Object : NINJA Flight Interdiction

**COMMUNICATION TECHNIQUE
NINJA "1" / NINJA 2**

N°3/2003
Issue 1
Date: 30/07/03
Pages 1/2

**Technical communication
NINJA "1" / NINJA 2**

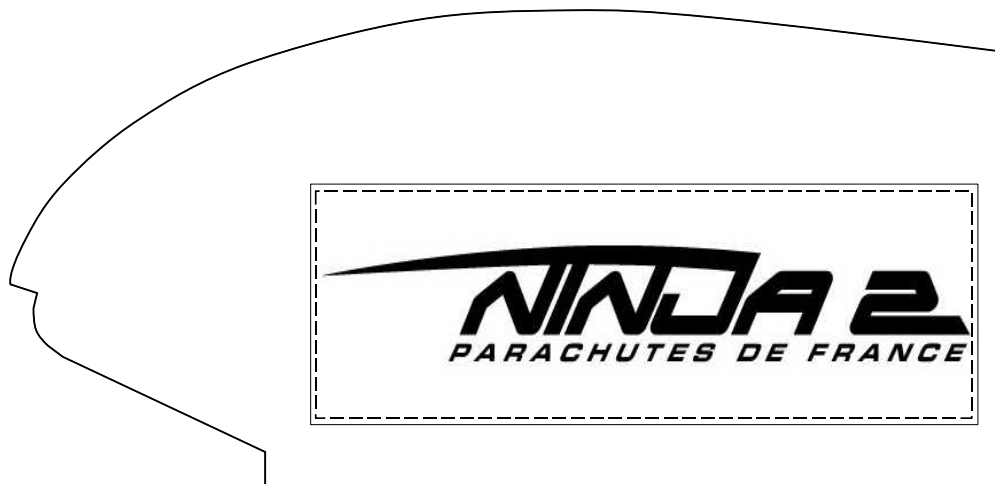
Identification:

Parachutes de France autorise d'emploi uniquement les voilures Ninja 2 identifiées par:

- Le panneau marque tamponné " NINJA 2 " à l'extrados central.
- La présence du marquage suivant sur les saumons de voilure:
